**VILLAGE OF DOWNERS GROVE  
REPORT FOR THE VILLAGE COUNCIL MEETING  
NOVEMBER 2, 2010 AGENDA**

SUBJECT:	TYPE:	SUBMITTED BY:
Lot Consolidation and Special Use for Automobile Repair Facility at 212 Ogden Avenue	<ul style="list-style-type: none"> <li>✓ Resolution</li> <li>✓ Ordinance</li> <li>Motion</li> <li>Discussion Only</li> </ul>	Tom Dabareiner, AICP Community Development Director

<b>SUBJECT:</b>	<b>TYPE:</b>	<b>SUBMITTED BY:</b>
PC-10-10 212 Ogden Avenue	Final Plat of Subdivision & Special Use for an Automobile Repair Facility	Damir Latinovic, AICP Planner

1 SITE PHOTOMETRIC PLAN  
RHO-1 1/16"=1'-0"

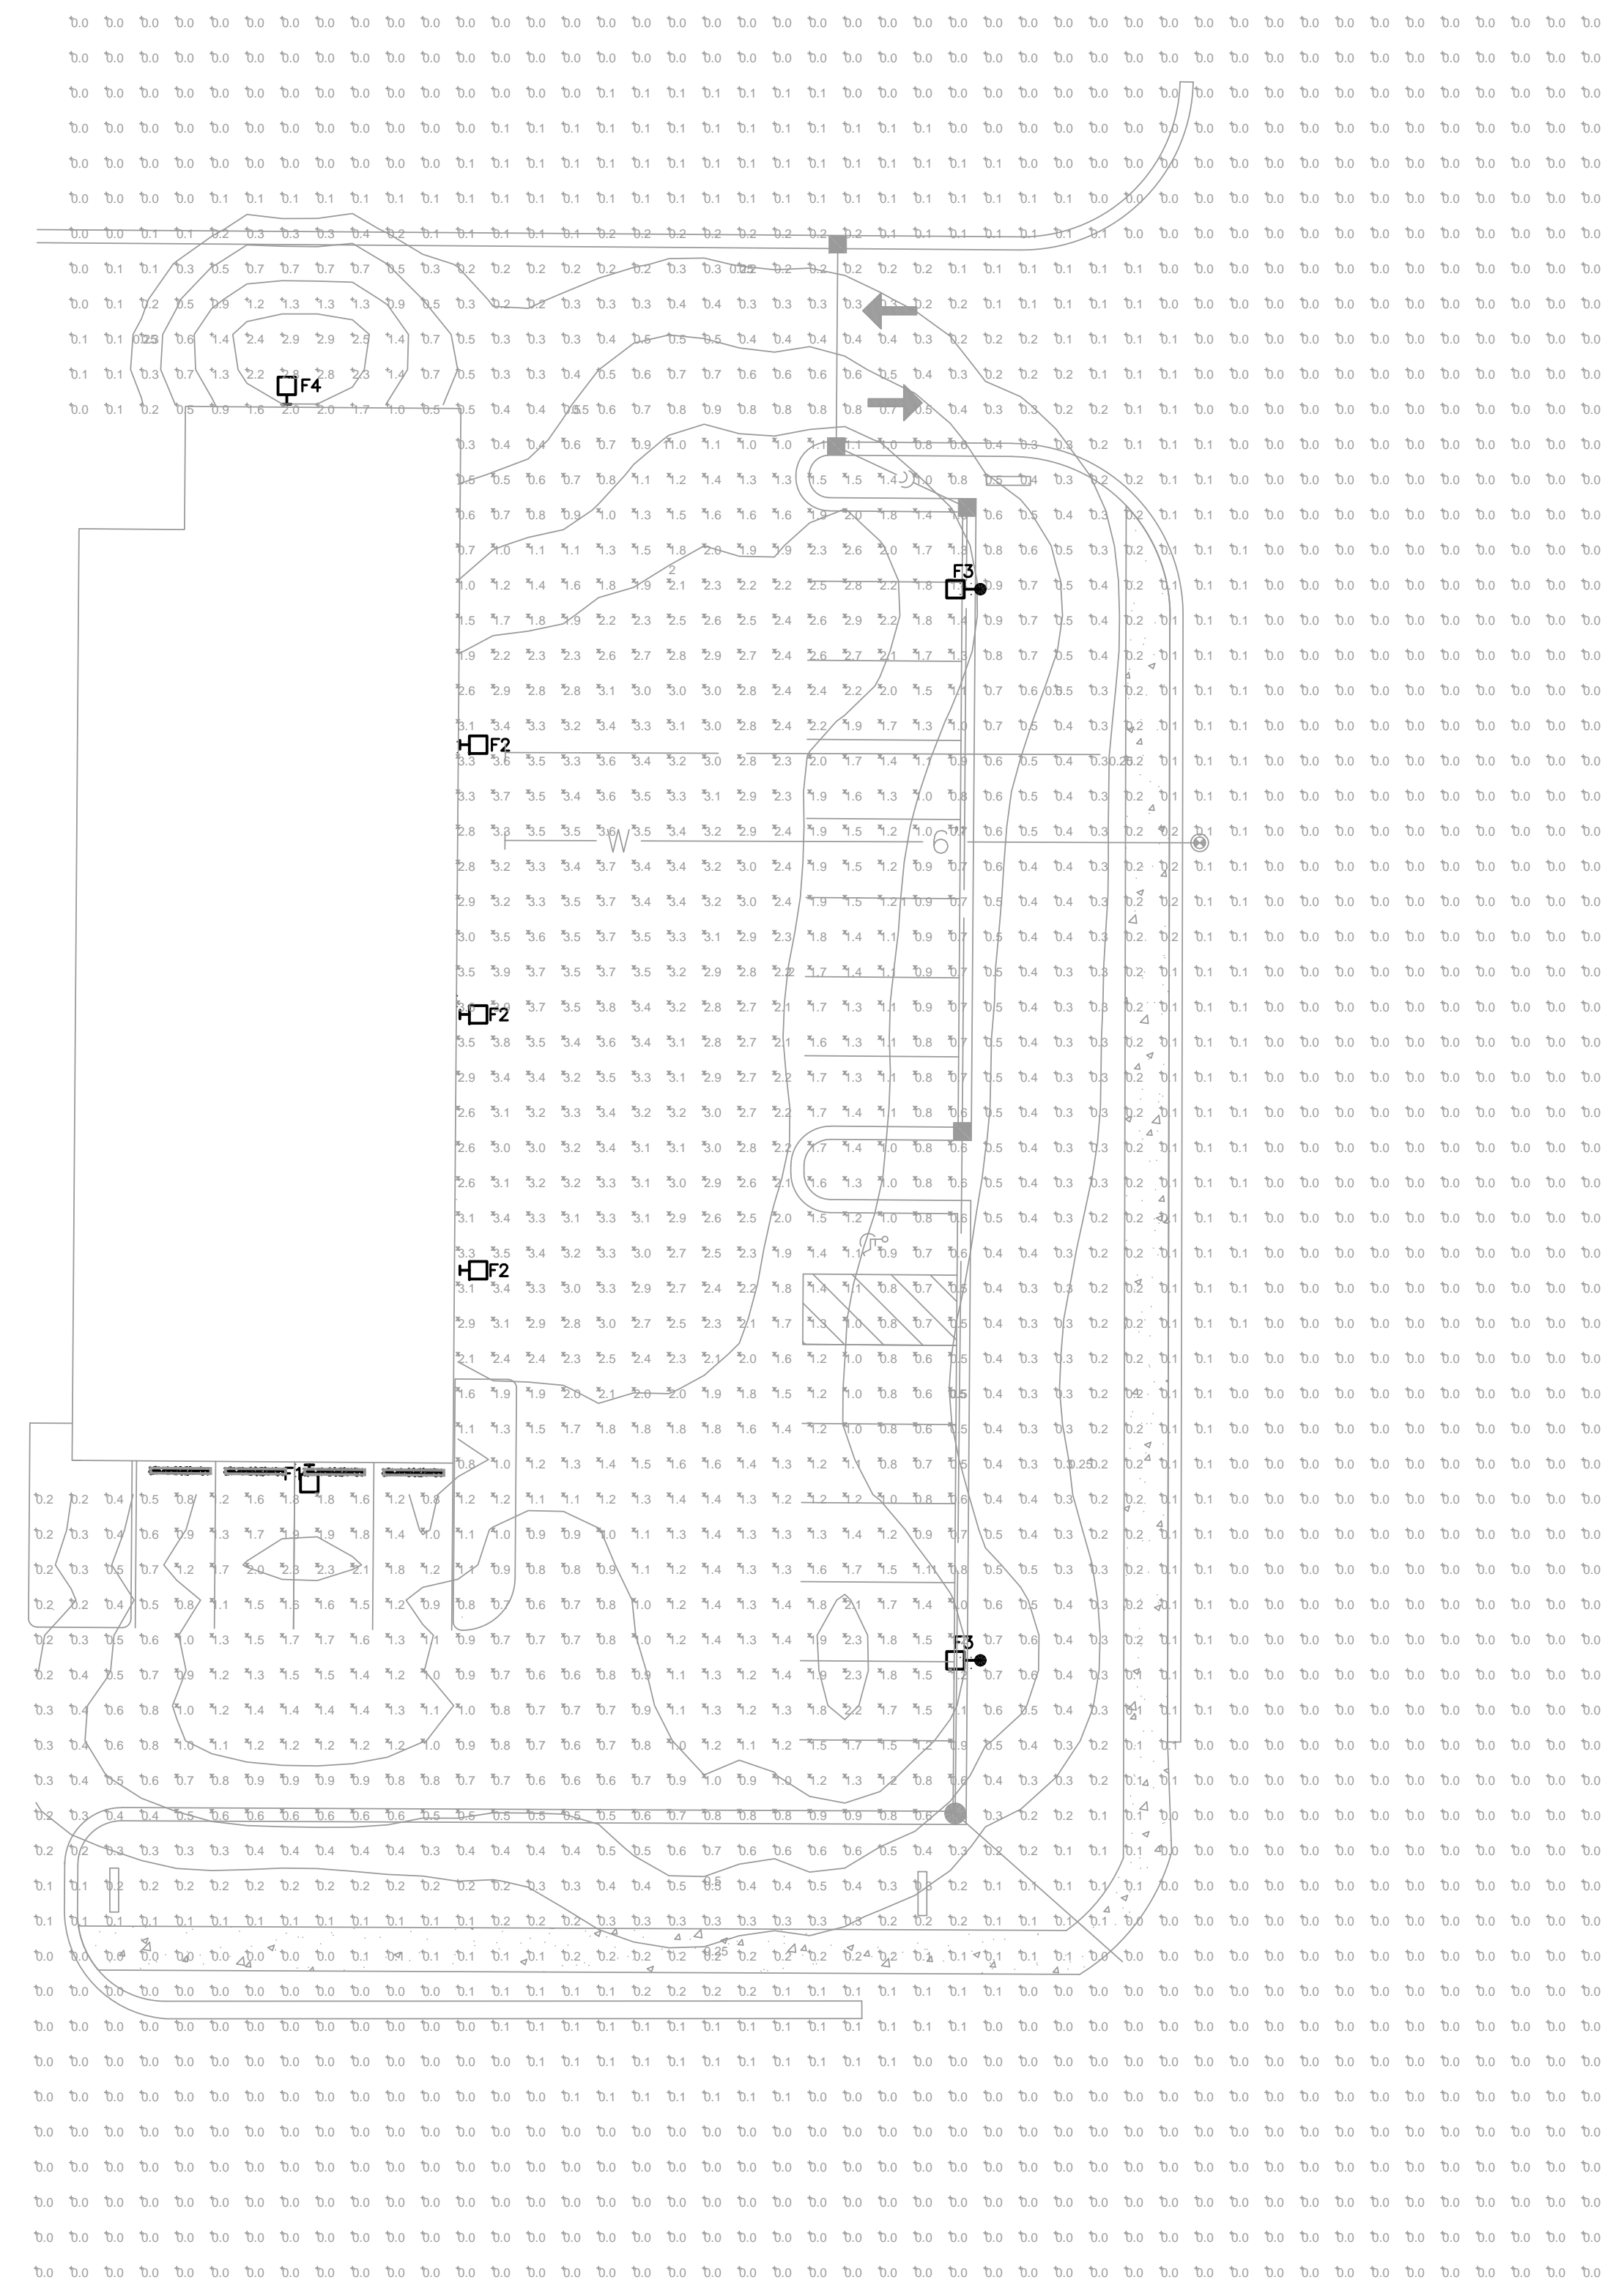
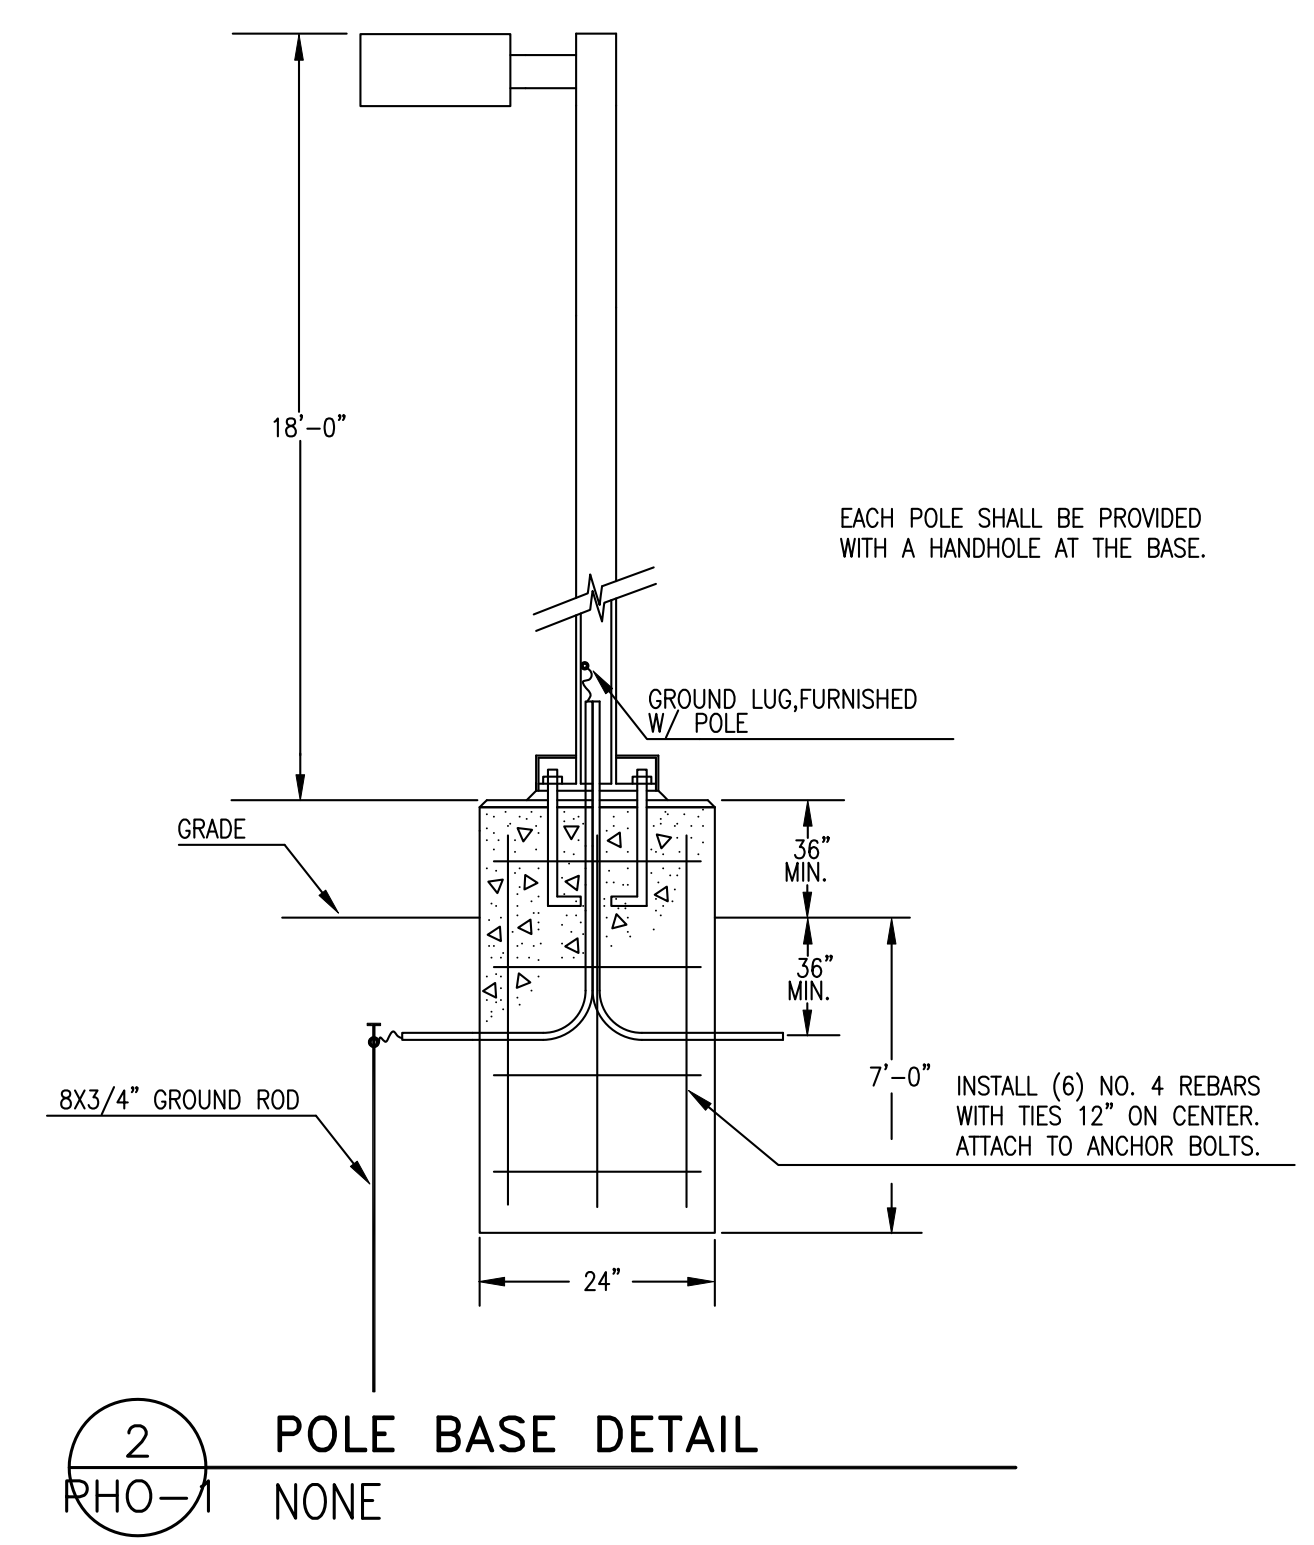
14. A revised photometric plan must be submitted prior to issuance of the building permit indicating that the foot candle readings at the north property line will not exceed 0.1 foot candles.

- 14. A REVISED PHOTOMETRIC PLAN MUST BE SUBMITTED PRIOR TO ISSUANCE OF THE BUILDING PERMIT INDICATING THAT THE FOOT CANDLE READINGS AT THE NORTH PROPERTY LINE WILL NOT EXCEED 0.1 FOOT CANDLES.**
